Mr. Bart McDonough, Town Planner Town of Kittery, Maine 200 Rogers Road Kittery, Maine 03904 December 2nd, 2021 Project No. C206-21

RE: Site Plan Review Application – Review Memo Revisions Terra Cotta Pasta Company (Tax Map 3, Lot 1) 52 State Road, Kittery, Maine

| | | TAX MAP 3, LOT 1 | TE | RADING & UTILITY PL. ERRA COTTA EXPANSI TE ROAD, KITTERY, M | ON |
|-----------------|----------|---|-----------------|--|------------------|
| /ISIONS | | | JOB NO: C206-21 | FILE: TERRA COTTA BASE.DWG | SHEET: 3 |

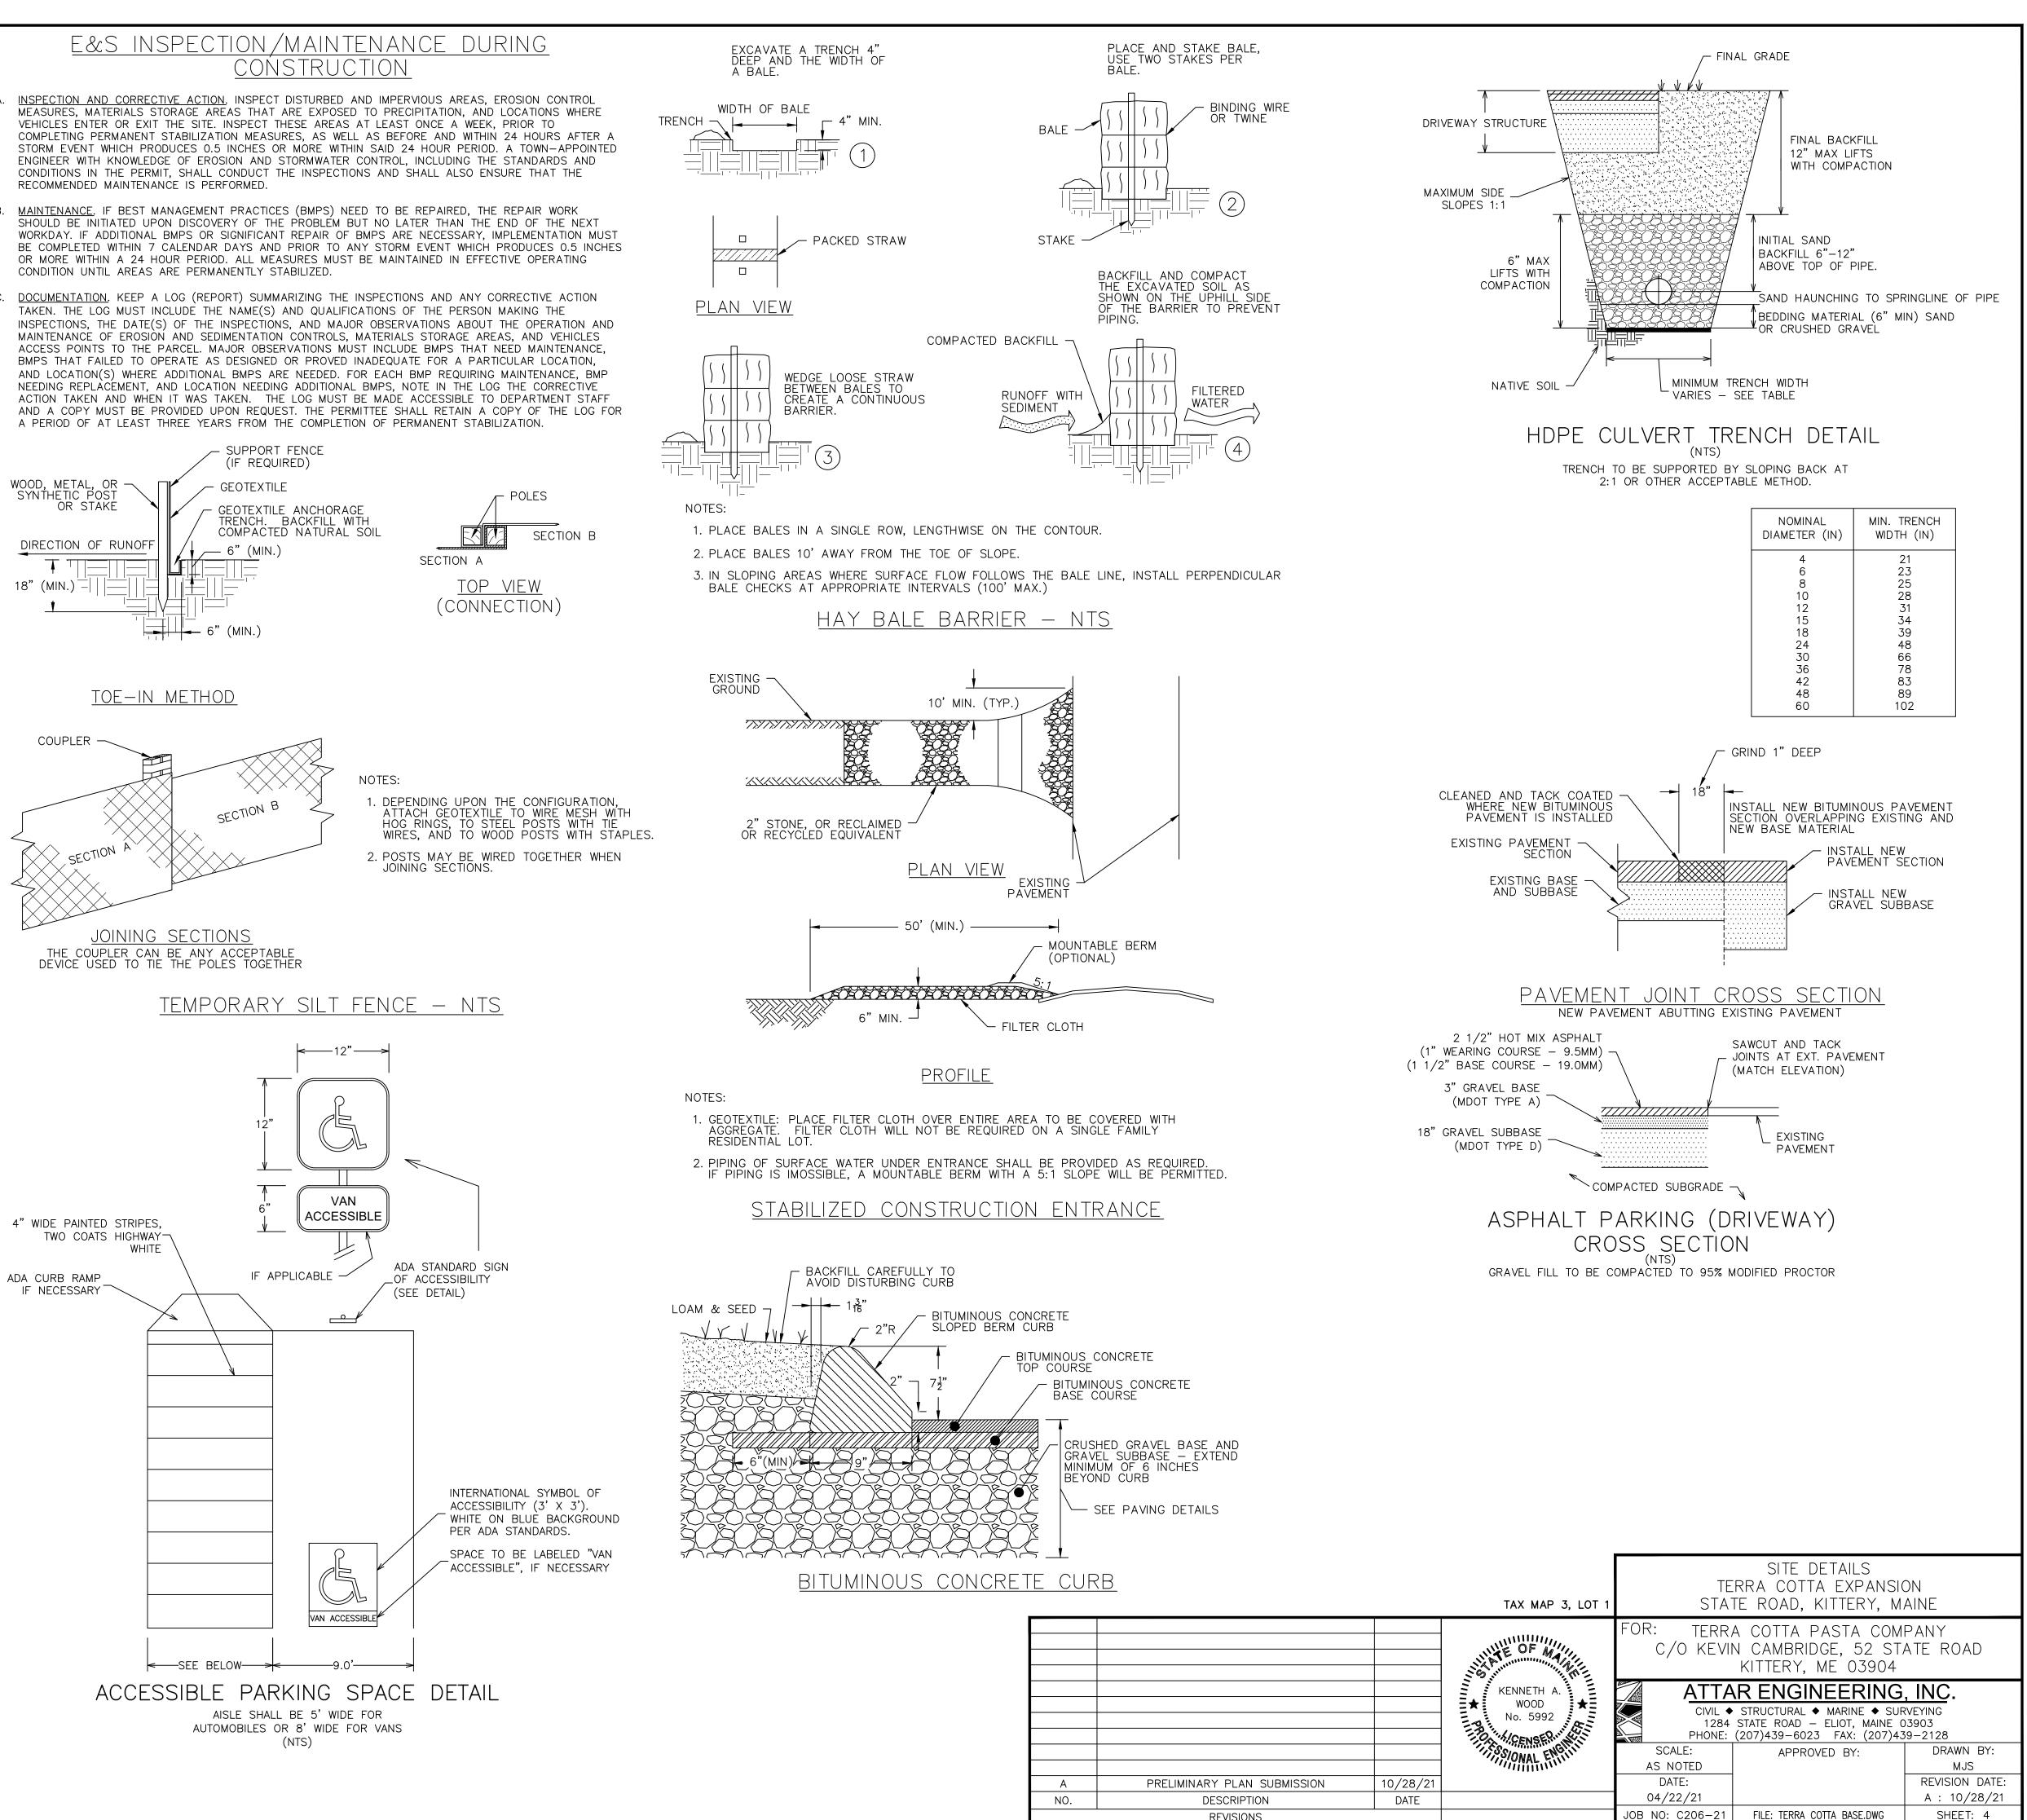
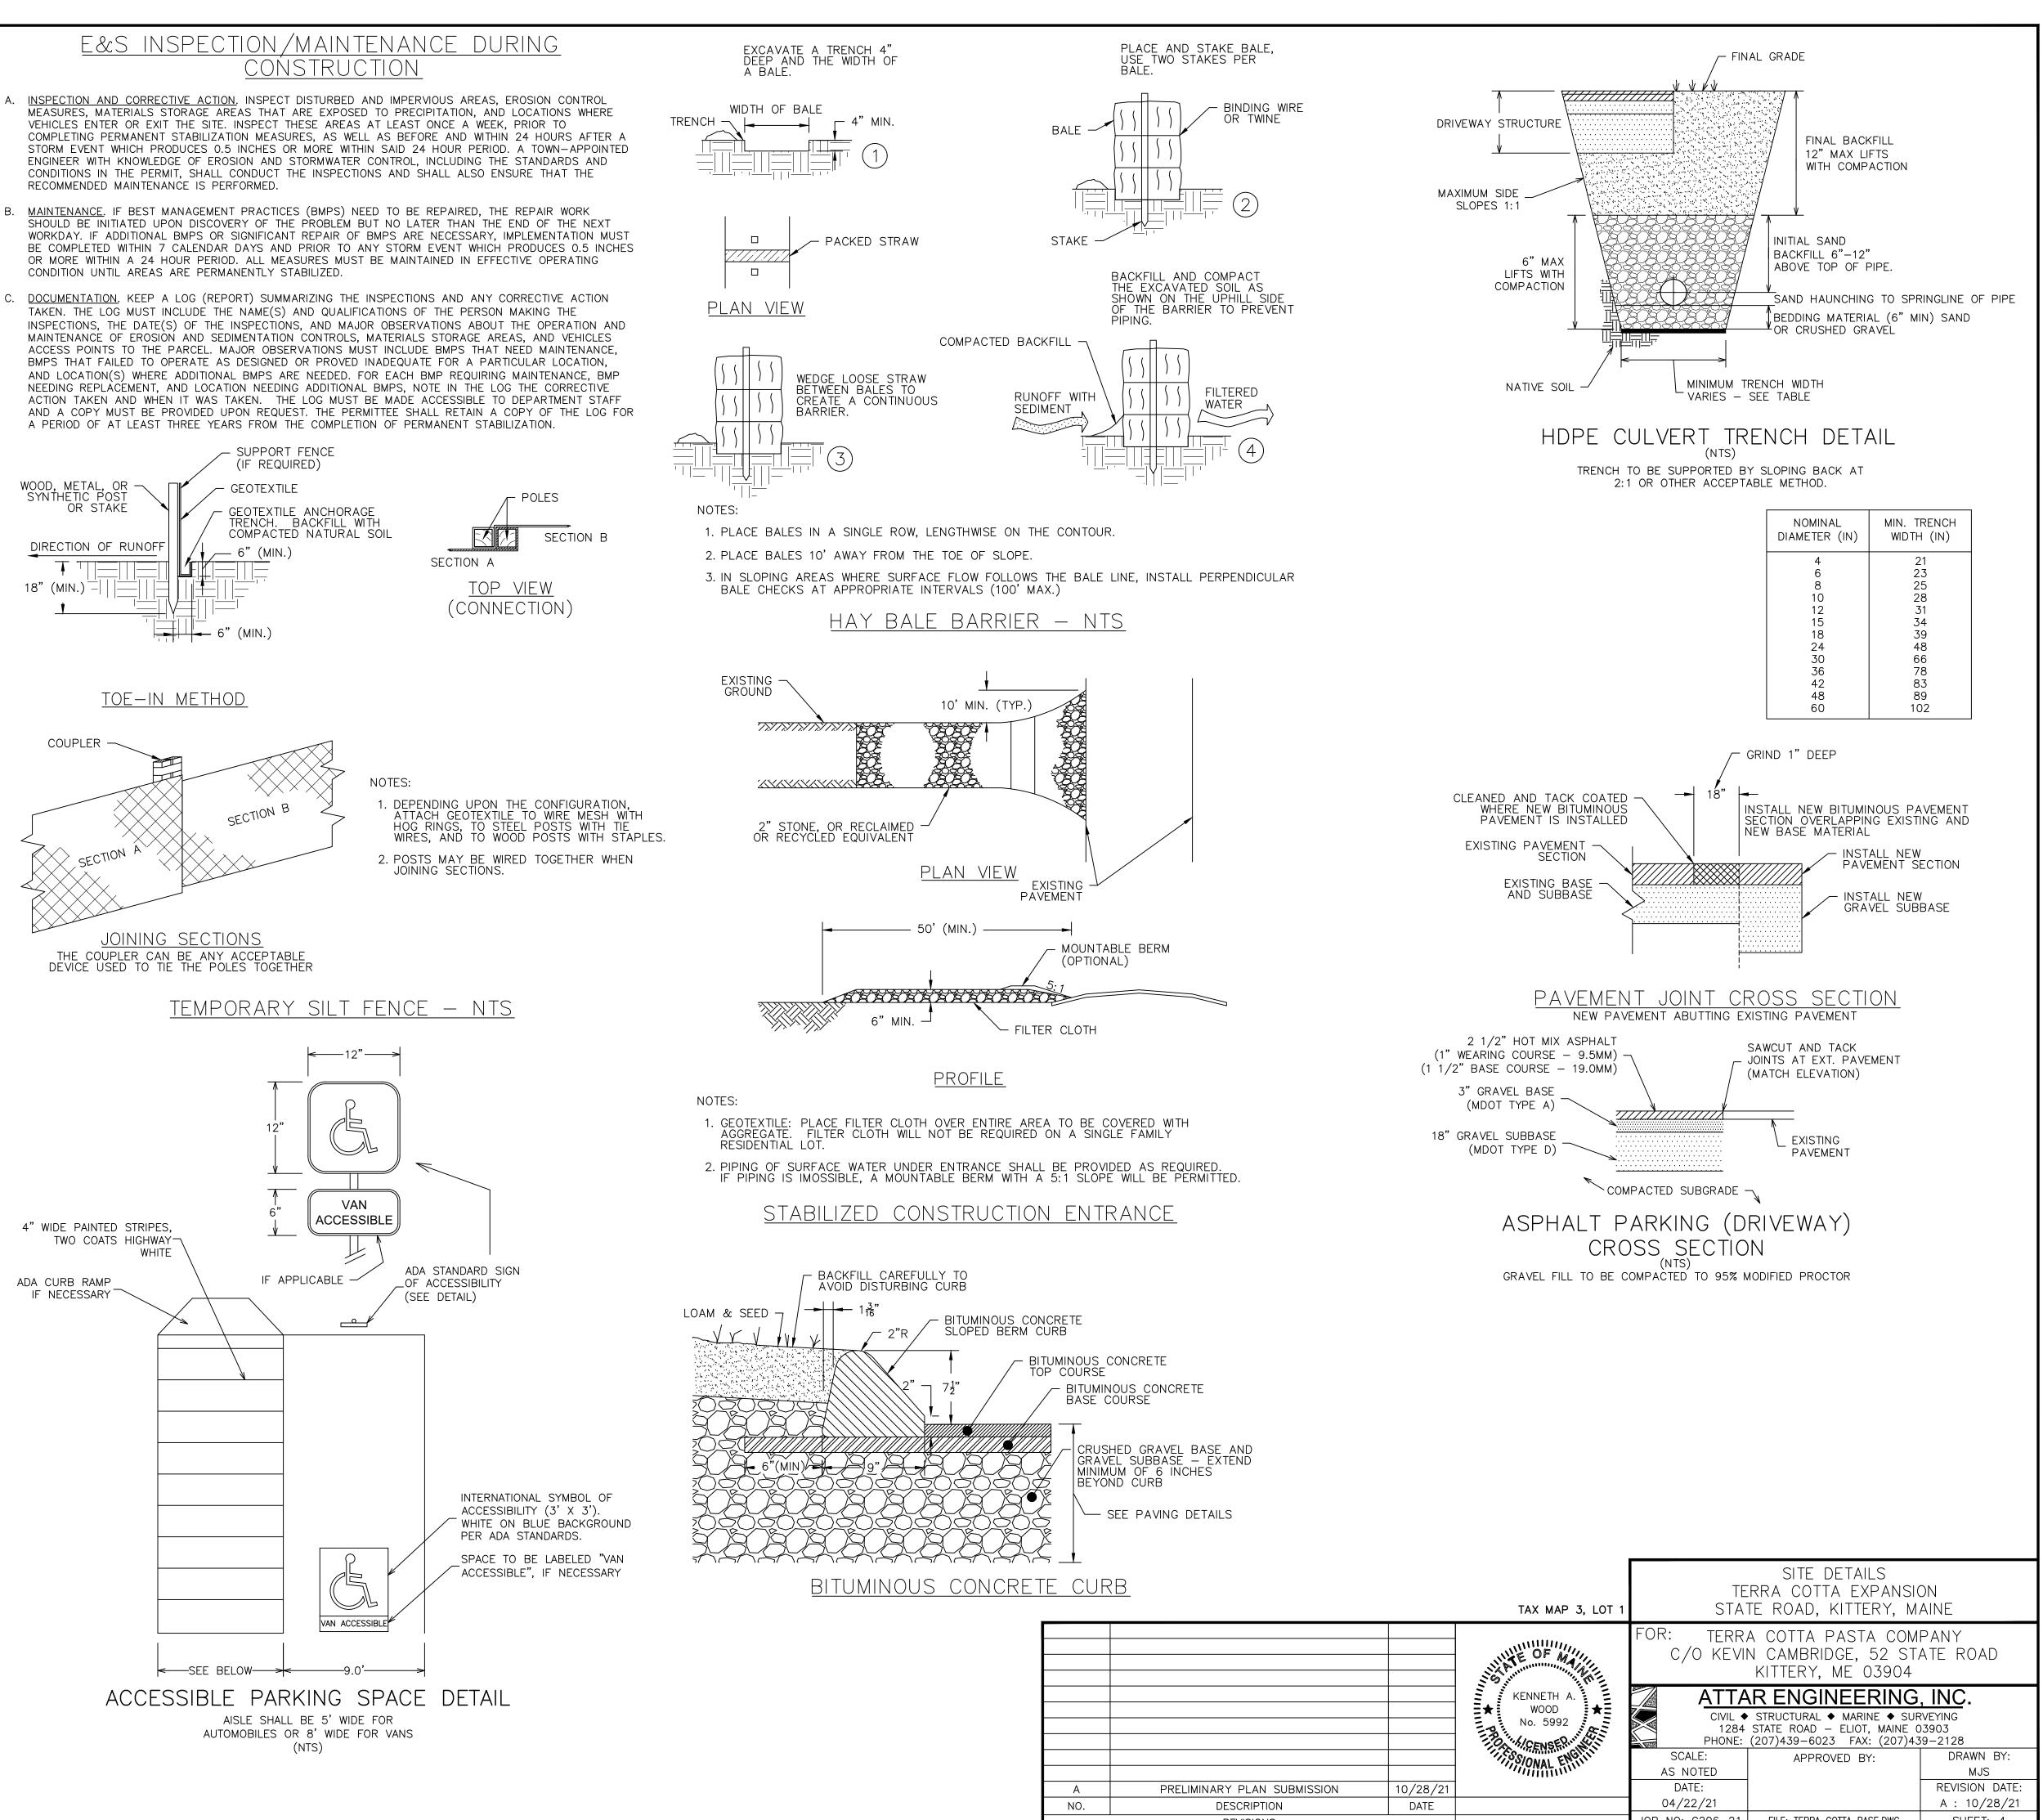
- Sheet 3 (Grading & Utility Plan) has been revised to include a solid-shade hatch to designate areas that are to be dedicated to landscaping in the developed condition. General Note #4 on Sheet 3 has been added to demonstrate compliance with §16.3.2.9.D(1)(i) and §16.3.2.9.D(4)(a).

- Sheet 3 has been revised to include a species-specific planting list for the proposed trees and shrubs to be located alongside the rear parking lot, as per §16.3.2.9.D(4)(e).

- Sheet 3 has been revised to depict snow storage locations around the parking lot and rear loading area. General Note #5 on Sheet 3 has been added with the suggested language for excess snow being carried off-site.
